Reply to International Search Report (Translation)

The CN2221620Y (referenced document one) and CN2381761Y (referenced document two) was referenced by the International Preliminary Examination Authority against claims 1, 4,5 and 6.

referenced document on e

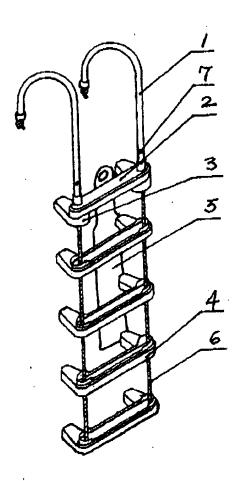
The referenced document one refers to a folding emergency ladder, which comprises two hooks (1), two cords (6) fixed to ends of the two hooks (1) and rungs (4) fixed to the two cords. Although there is also a strip-shaped supporting plate (3), such supporting plate (3) is fixed to ends of said hooks (1), functioning to form a hooking-and-hanging device together with the connecting plate (2) and the two hooks (1) at top of said emergency ladder, while in this patent application there are multiple supporting attachments (6) that are installed at the connections of the ladder belts (4) and ladder rungs (5), functioning to keep the ladder rungs at a certain distance from the wall surface to facilitate ladder users to climb. Conclusion: shapes, structures, locations, their functions and performances of the two ladders are totally different. This patent application is essentially different from the referenced document one, and said claim 1 together with claims 4, 5 do confirm to the Article 33 (3) for involvement on inventive step (non-obvious) of PCT.

reference document two

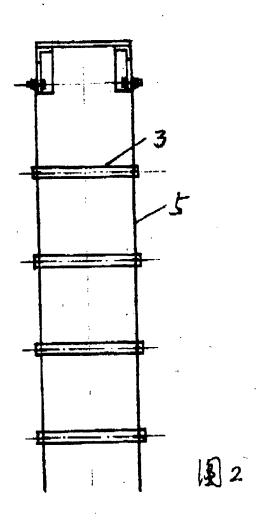
The referenced document two refers to another emergency ladder for multi-storied buildings, which has rungs (3) wrapped with fire-retardant asbestos cloth that only functions to prevent fire, while the rungs (5) in this patent application have outer layers of fire-retardant braided belts that can not only prevent fire but also greatly increase strength of the rungs (5) and facilitate their fixing onto the left and right ladder belts (4). Conclusion: functions and performances of the two ladders are substantially different, and said claim 6 also conforms to the Article 33 (3) for involvement on inventive step (non-obvious) of PCT.
